## Product Change Notification / JAON-22RWTR531

### Notification Subject:

CCB 4251.001 Final Notice: Qualification of MTAI as an additional final test site for selected Atmel ATF1502AS, ATF1502ASL and ATF1504ASV device families available in 44L TQFP (10x10x1mm) package.

**CCB 4251.001**  
**Pre and Post Change Summary**  
**PCN# JAON-22RWTR531**

# Packing Information – Tray Drawing

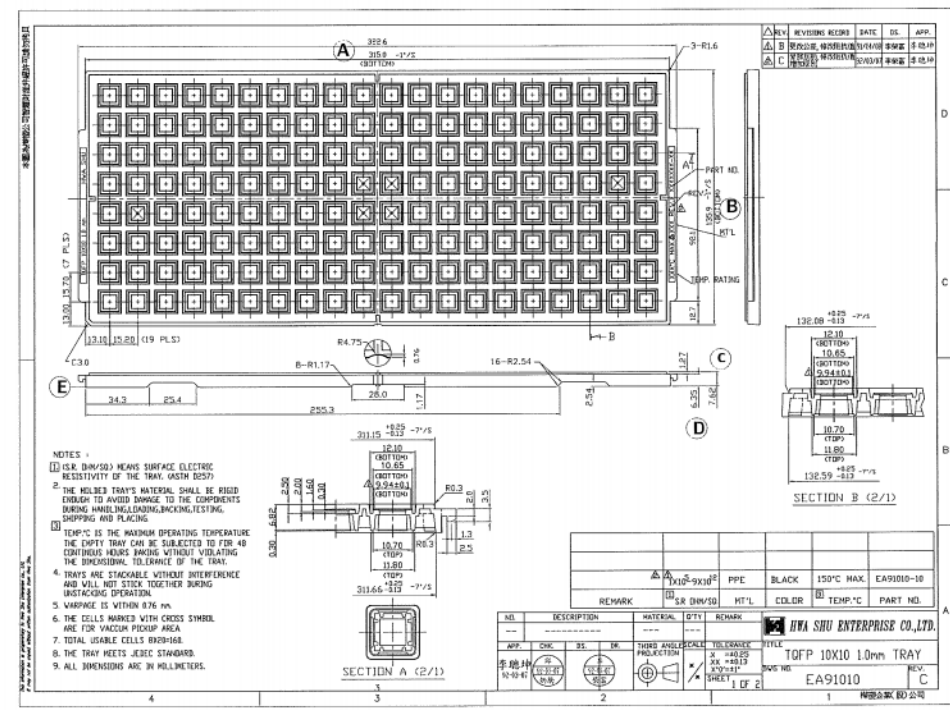
Plant	Pocket Pitch (X)	Pocket Pitch (Y)	Outer Pocket center to Tray edge (X)	Outer Pocket center to Tray edge (Y)	Bakeable Tray	Tray Matrix	Unit Per Tray	Tray Stack	Color
MPHL	15.20 mm	15.70 mm	13.10 mm	13.00 mm	Yes (150C MAX)	8x12	160	10+1	Black
MTAI	15.20 mm	15.70 mm	13.10 mm	13.00 mm	Yes (150C MAX)	8x12	160	10+1	Black

# Packing Information - Tray packing method

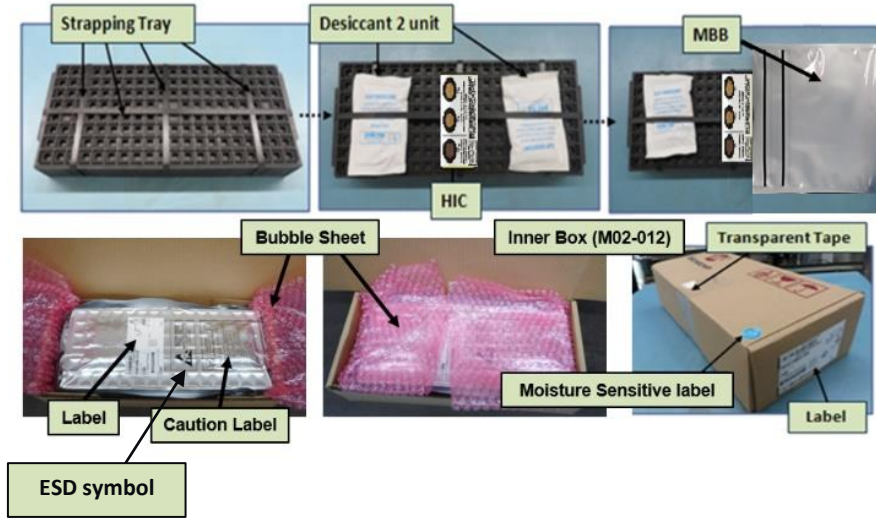
Drawing number	Dimension W x L x H (cm)	Carton		Number of Inner box(es) per carton
		Drawing number	Dimension W x L x H (cm)	
M02-012	16.2x37.1x8.8	M01-044 (SM)	37.0x38.0x11.0	2 : 1
		M01-045 (S4)	37.0x38.0x22.5	4 : 1
		M01-042 (Q4)	34.5x39.2x19.5	4 : 1
		M01-046 (S5)	37.0x39.0x39.0	8 : 1

# Packing Information - Cover Tape

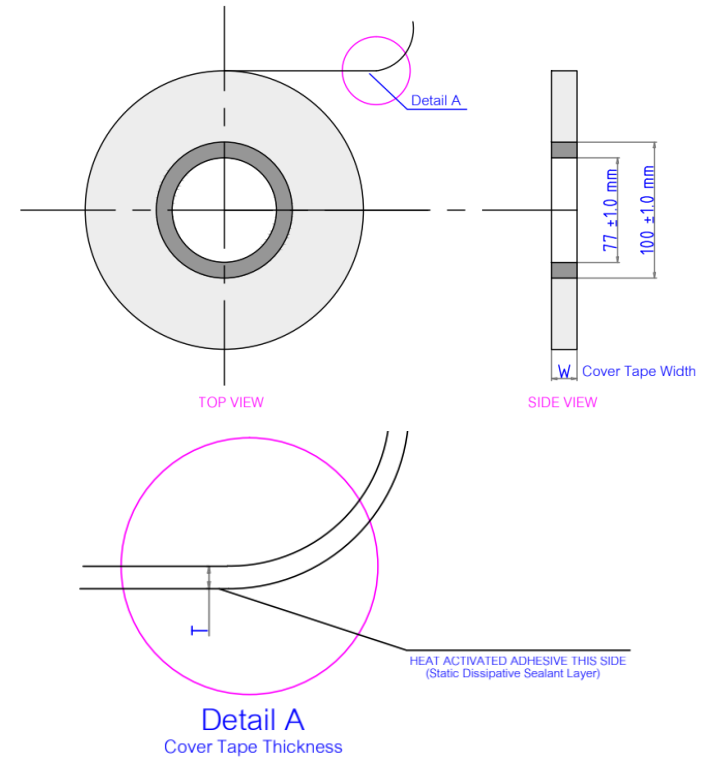
Plant	Carrier Width	Cover tape Width "W" (mm)	Thickness (mm)	Sealing Methodology
MPHL	24mm	21.30	0.050 +/-0.005	Pressure Seal
MTAI	24mm	21.00	0.050 +/-0.010	Heat Activate Seal

# Packing Information - Plastic Reel

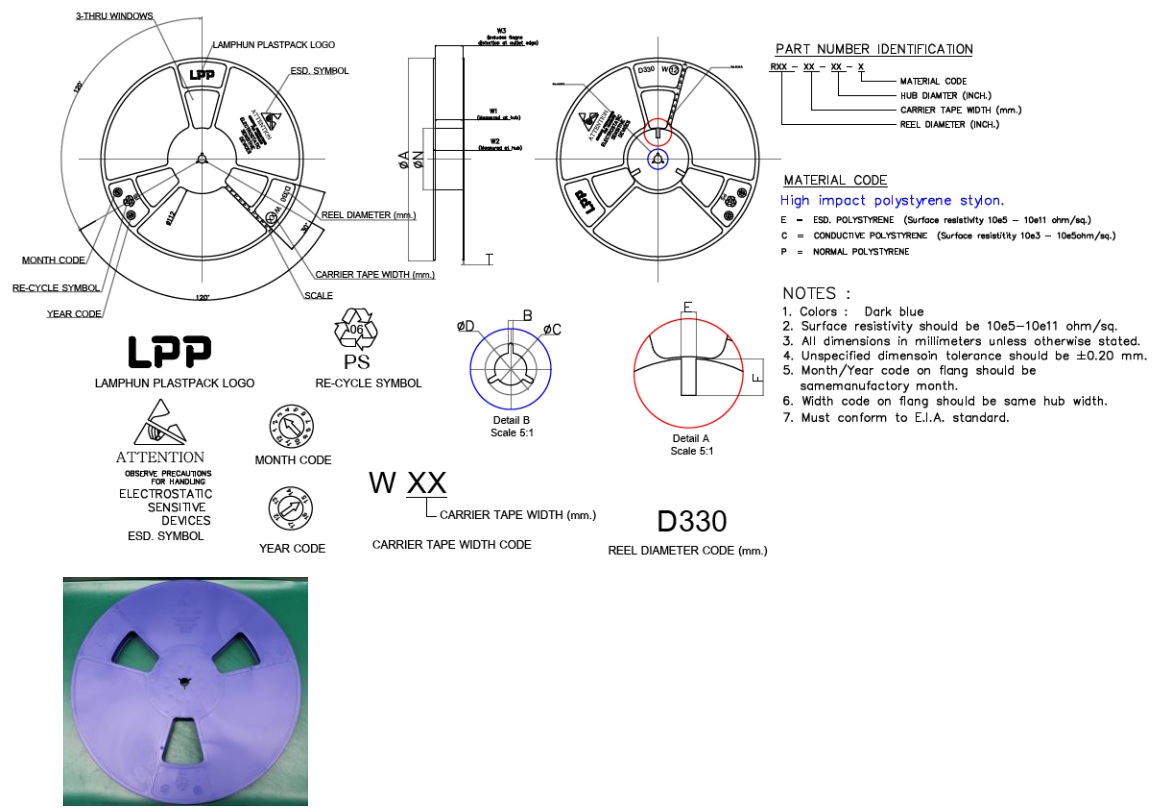
Plant	For Carrier Tape Width	Diameter	Hub	Color
MPHL	24mm	13inch (330mm)	4inch (100mm)	White
MTAI	24mm	13inch (330mm)	4inch (100mm)	Dark Blue

# Packing Information - T/R packing method

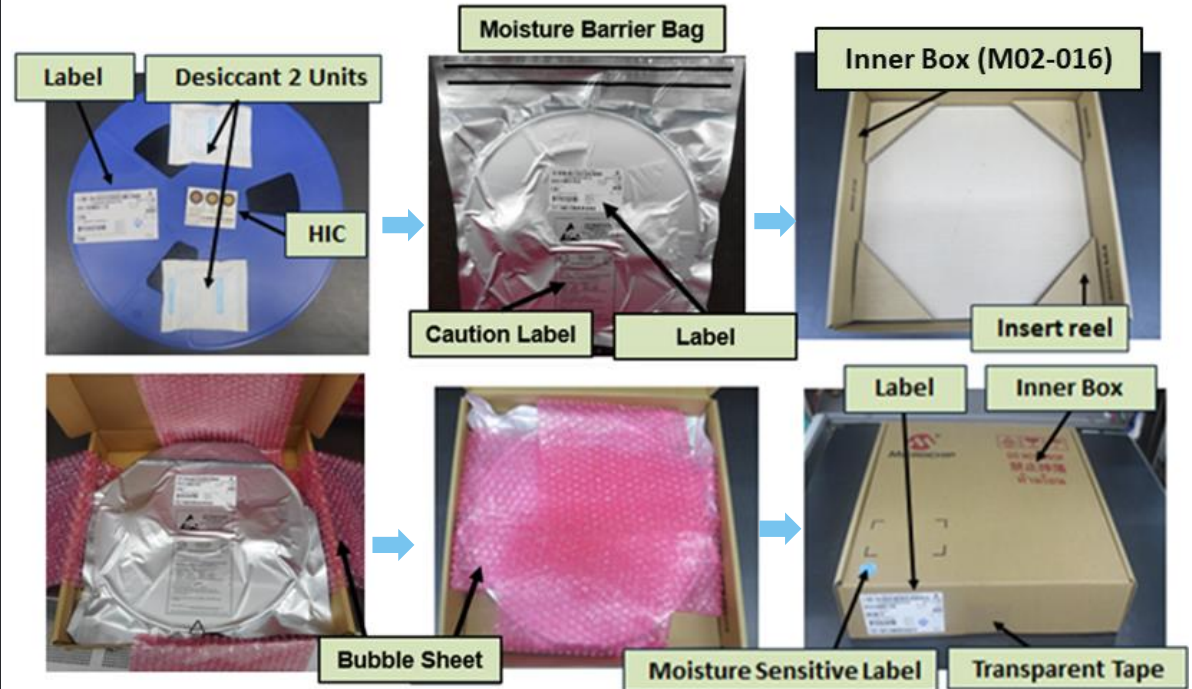
Inner box		Carton		Number of Inner box(es) per carton
M02-016 (Large)	37x35.3x7.7	M01-044 (SM)	37.0x38.0x11.0	
		M01-045 (S4)	37.0x38.0x22.5	2 : 1
		M01-046 (S5)	37.0x39.0x39.0	4 : 1
		M01-039 (TR)	28.6x37.5x36.2	4 : 1
		M01-047 (S3)	42.0x66.0x39.0	8 : 1
